DEPARTMENT OF TRANSPORTATION  
1401 EAST BROAD STREET  
RICHMOND, VIRGINIA 23219 2000

April 21, 2009

## MEMORANDUM

To: All Holders of the Virginia Department of Transportation's 2008 Road and Bridge Standards

STANDARD ENDWALL FOR PIPE UNDERDRAIN

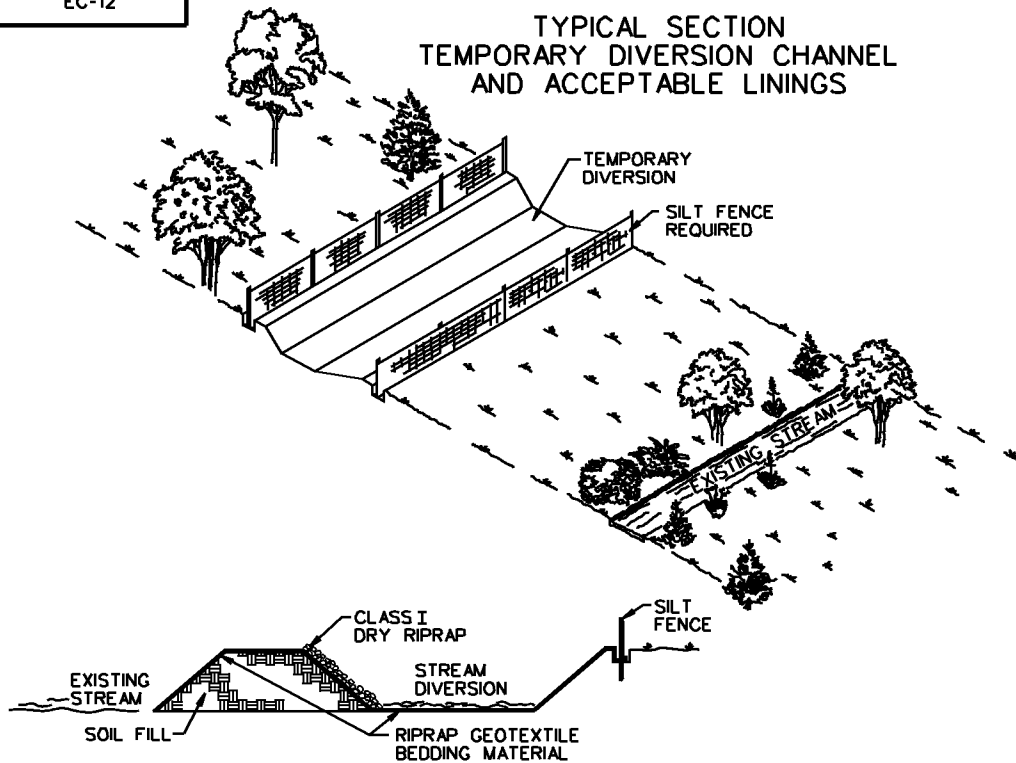
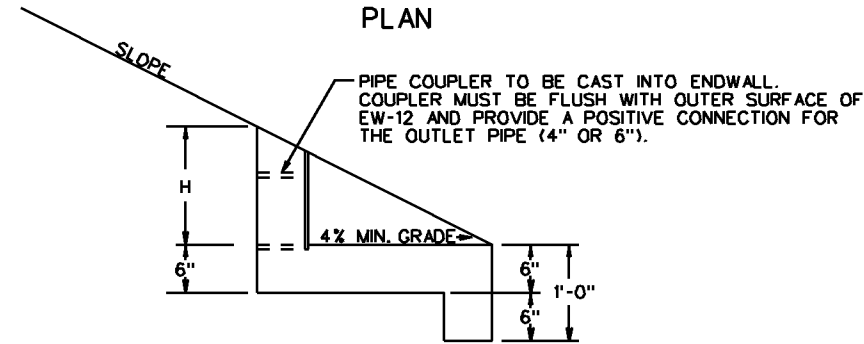
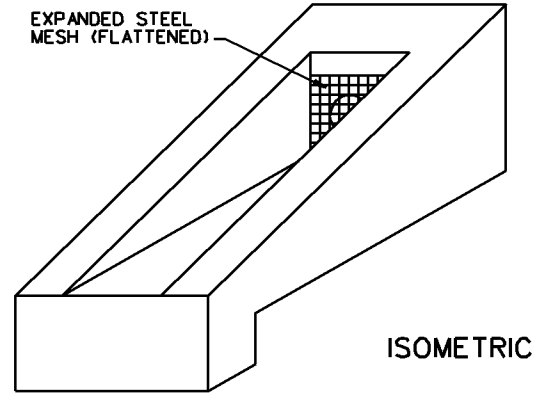
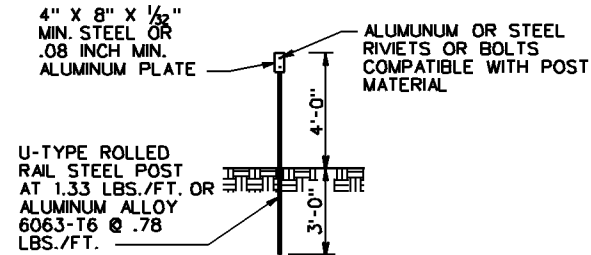
PAGE	INSERT	STANDARD	REVISION
101.32	IIS01_01	EW-12	Added requirement for a positive connection to be cast into EW-12
113.16	IIS01_02	EC-12	Removed construction crossing
113.18	IIS01_03	EC-14	New, Temporary Watercourse Crossing
203.05	IIS02_01	CG-12	Updated dimensions on the Type A
203.06	IIS02_01	CG-12	Updated dimensions and placement typicals

6. MARKER TO BE PLACED AT ALL EW-12 UNDERDRAIN INSTALLATIONS.
7. MARKER WILL BE PAID FOR IN ACCORDANCE WITH SECTION 501 OF THE ROAD AND BRIDGE SPECIFICATIONS.

# CG-12 DETECTABLE WARNING SURFACE

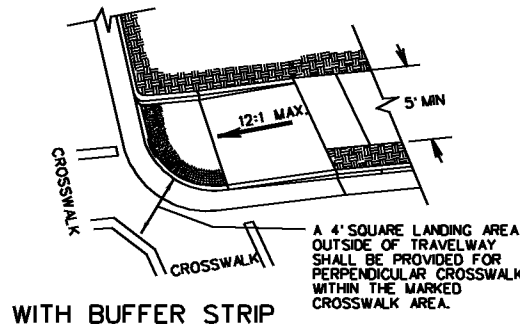
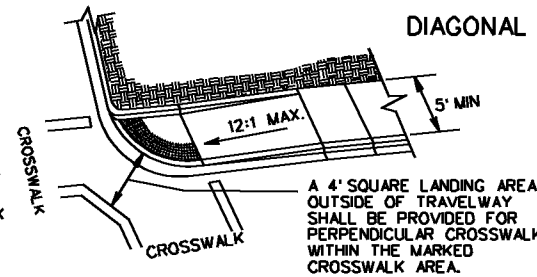
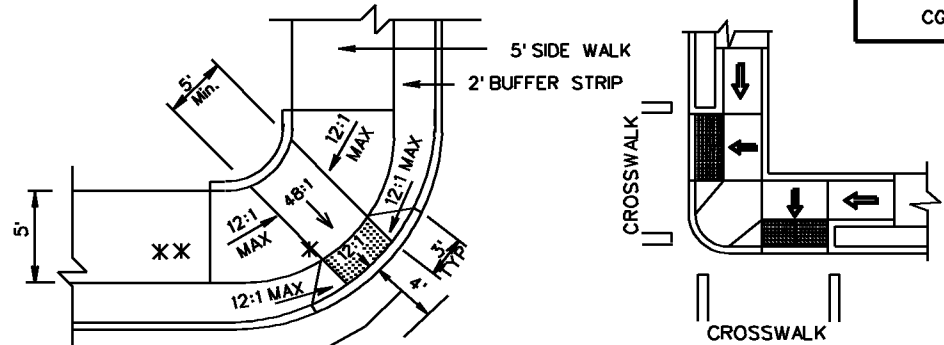
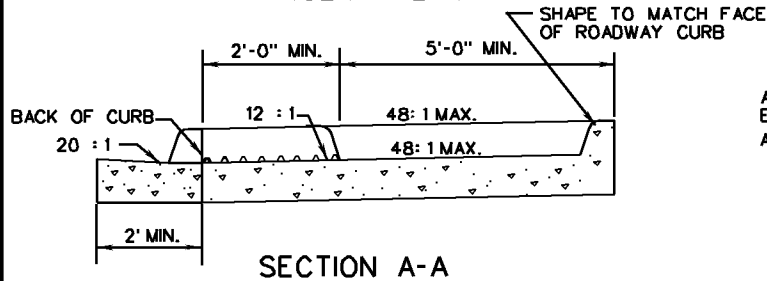
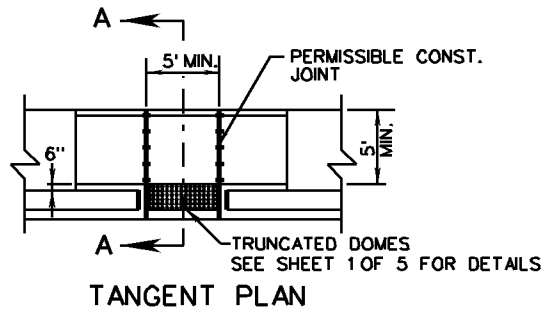
203.07	IIS02_02	CG-12	Added drawings showing application with and without a buffer strip
203.08	IIS02_02	CG-12	Added placement typical and flared opening

**CG-12 DETECTABLE WARNING SURFACE**  
**MEDIAN AND REFUGE ISLAND APPLICATIONS**  
 VIRGINIA DEPARTMENT OF TRANSPORTATION

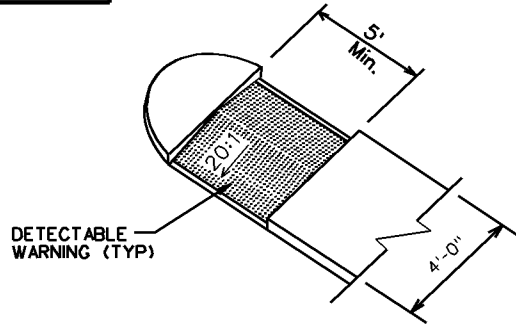
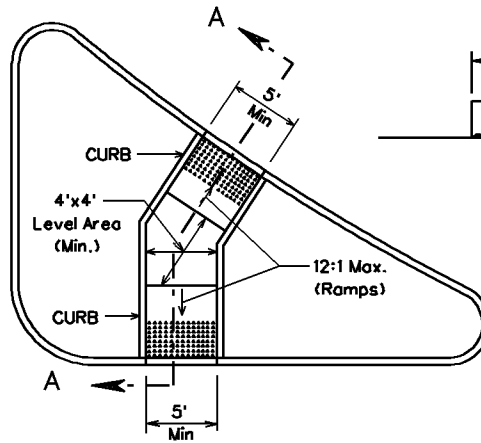
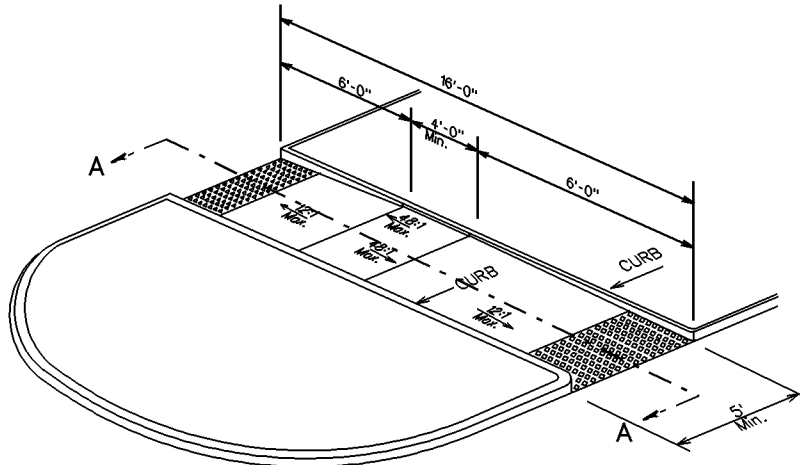
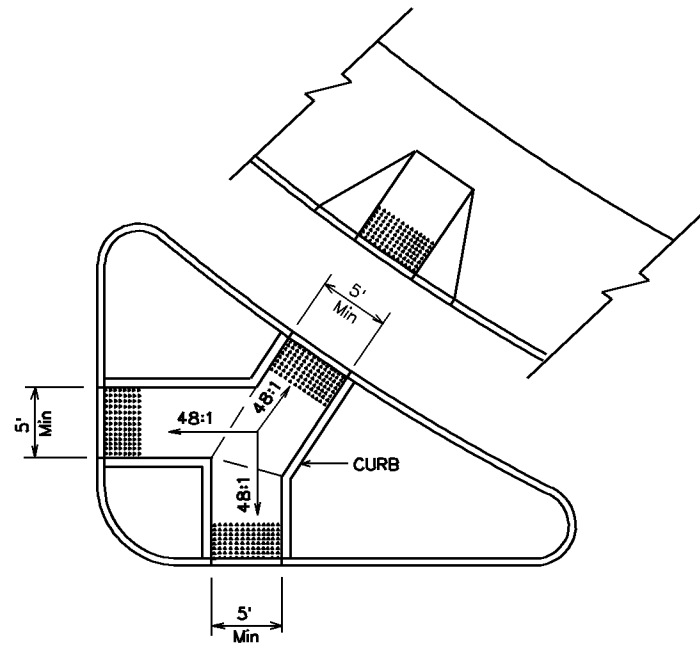
203.08A	IIS02_03	CG-12	New, Applies to medians and refuge islands
301.09	IIS03_01	PR-3	Clarified drawing to match dimensions
301.12	IIS03_02	PR-4	Clarified drawing to match dimensions

# STANDARD GUARDRAIL HARDWARE

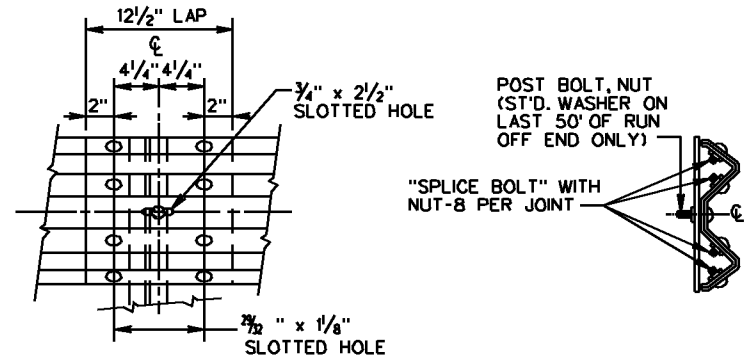
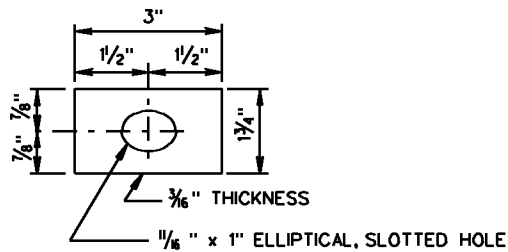
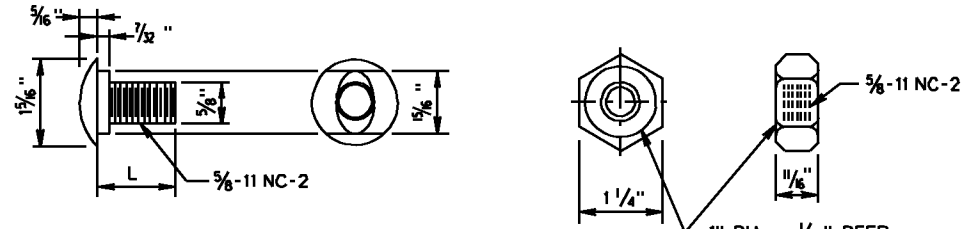
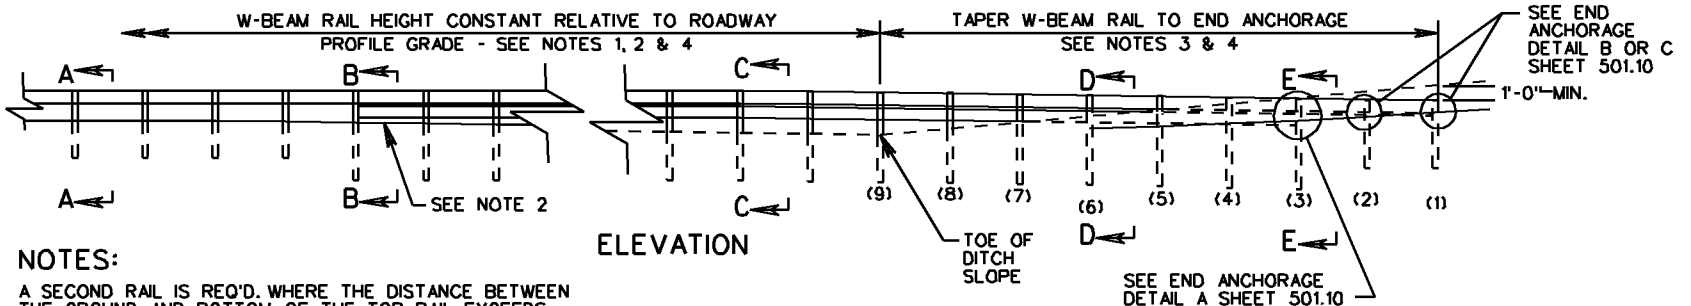
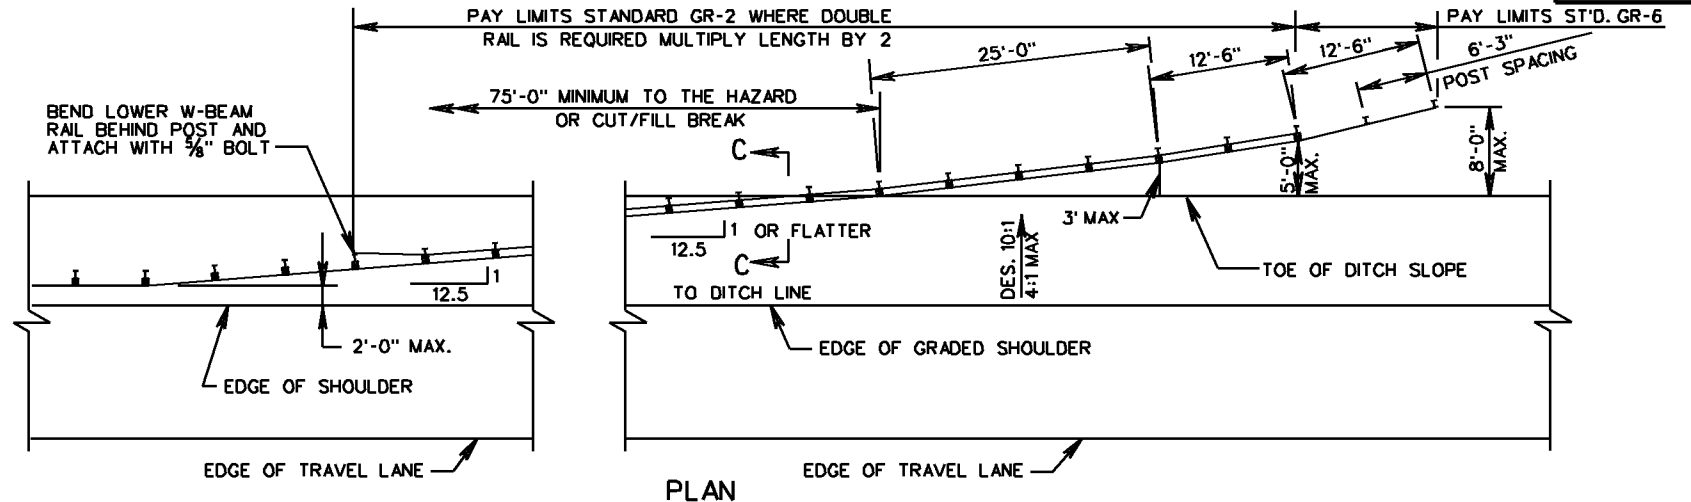
501.01	IIS05_04	GR-HDW	Deleted notes referencing steel blockouts
501.09	IIS05_05	GR-6	Revised note 1
501.27	IIS05_06	GR-FOA-1	Revised rubrail details 7 & 8, and blockout thickness charts.
1307.10	IIS13_01	PA-1,2,3	Revised drawings
1310.11	IIS13_02	PF-8	New, Signal Pole Foundation
1323.10	IIS13_03	SSP-VIA	Added exit sign panel
1324.10	IIS13_04	OSS-1	Added note #7
1324.12	IIS13_05	OSS-1	Revised notes
1325.11	IIS13_06	SPD-1	Revised table
1325.21	IIS13_07	SPD-2	Revised installation detail and notes
1325.31	IIS13_08	SPD-3	Revised table
1325.72	IIS13_09	SPD-7	Revised table
1330.50	IIS13_10	PM-5	Added taper length table
1330.90	IIS13_11	PM-9	Revised drawing for "PASSING ONE DIRECTION" and "NO PASSING"
